# INTERNAL MEMORANDUM

To: David Cross  
From: Matt Davies (Ecologist)  
Ext: 5278  
Memo number: 3  
Date of previous memo: 10/10/2025  
Date: 10/11/2025

**SUBJECT: P/25/0165 | Demolition, ground reclamation and remediation and outline planning application with all matters reserved (except for the main access points) for the comprehensive redevelopment of the former Hoover site to create a new neighbourhood, including up to 441 new homes, 1.5 hectares of employment land (including B1 (business), B2 (general industrial), B8 (storage and distribution) and sui generis uses), community hub (including A1 (shops), A2 (financial and professional services) A3 (food and drink), B1 (business), D1 (non-residential institutions) and sui generis uses, community heat hub, metro station and transport hub (including transport interchange and parking), a network of open spaces (including parkland, active travel routes, areas for informal recreation and SUDS attenuation features) together with associated works, including improvement/works to the highway network.| Former Hoovers Site Pentrebach Road Pentrebach**

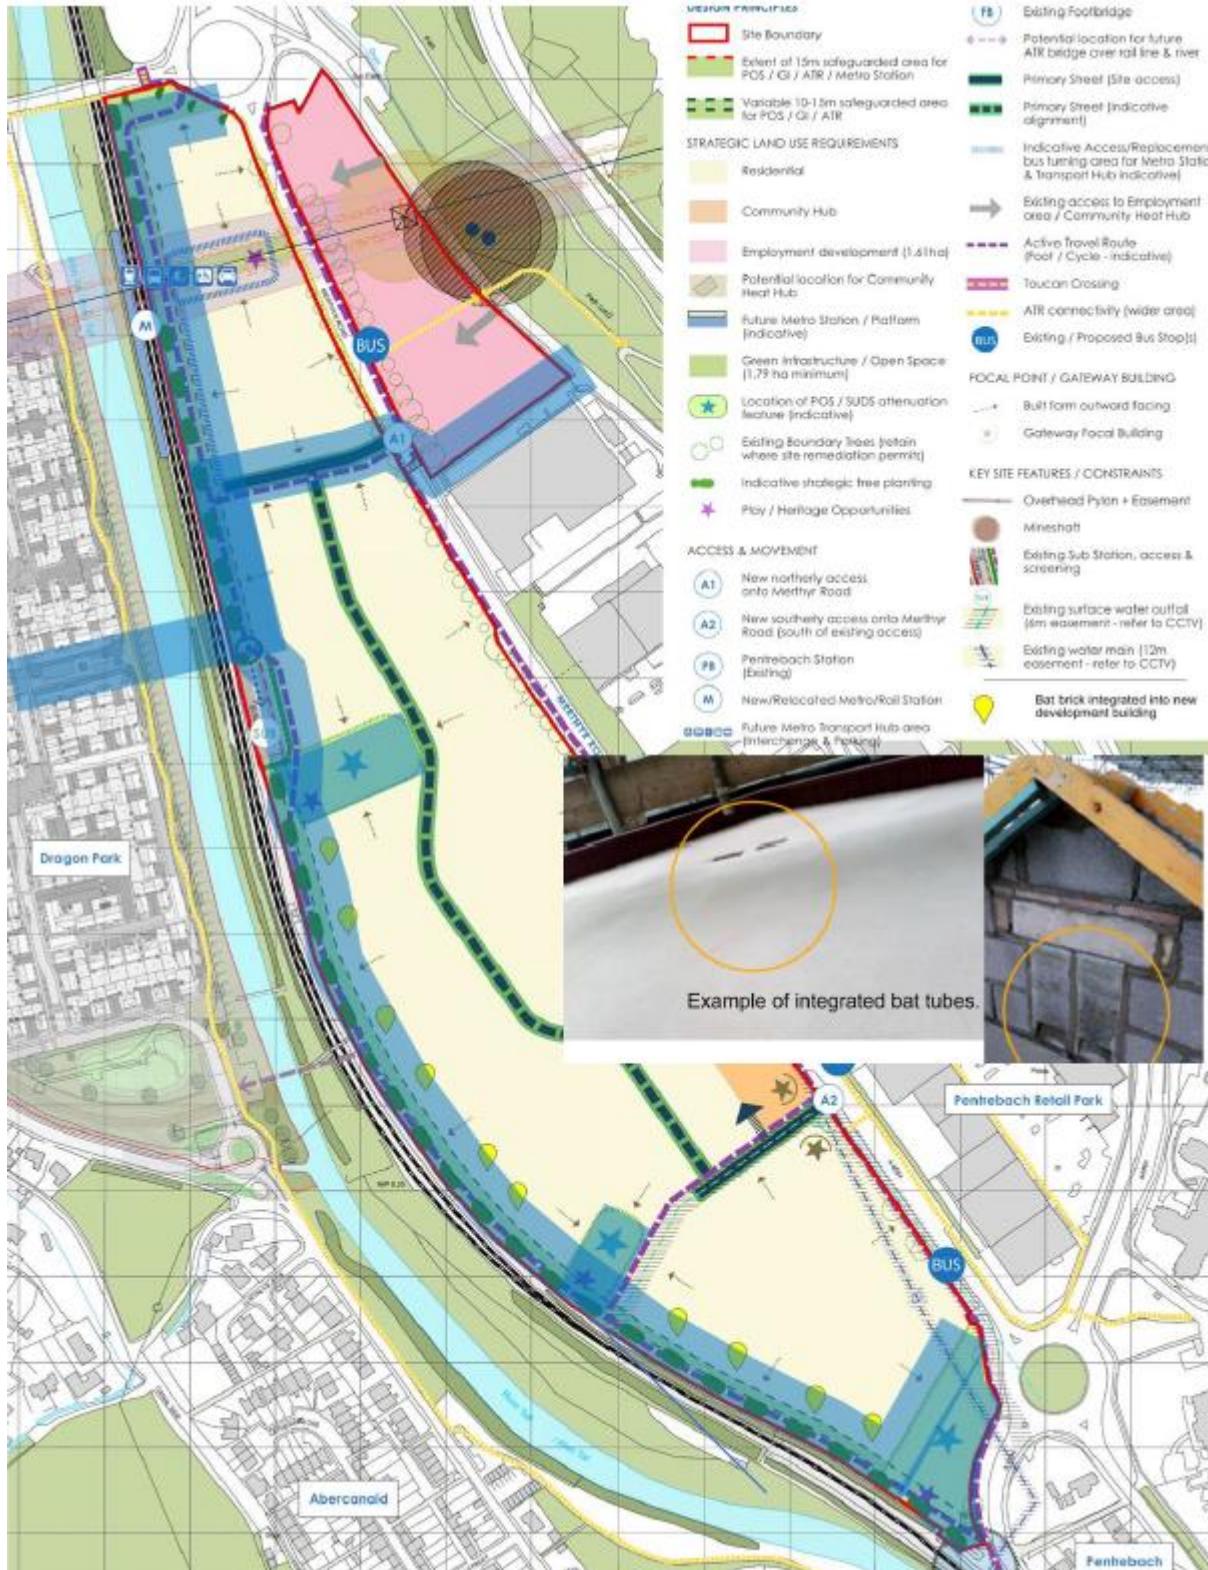
This report recommends a total of x10 integrated bat boxes facing boundary habitat. This is a low number given the number of properties proposed (up to 441). All houses in the areas highlighted (in blue) in the plan below should have an integrated bat or a bird box as appropriate.

NB these are not the only areas that will need to be kept dark, simply those dark areas within/alongside which there will need to be wildlife provision in the form of bat and bird boxes.

All site boundaries where there is habitat will also need to be dark within the lighting scheme along with any areas of habitat within the site.

The plan below not only includes a suggestion for a west-east dark corridor running right across the Hoover site, but also how this will link up to the west-east dark corridor already agreed for the adjacent Dragon Park development to the west of the Hoover site.
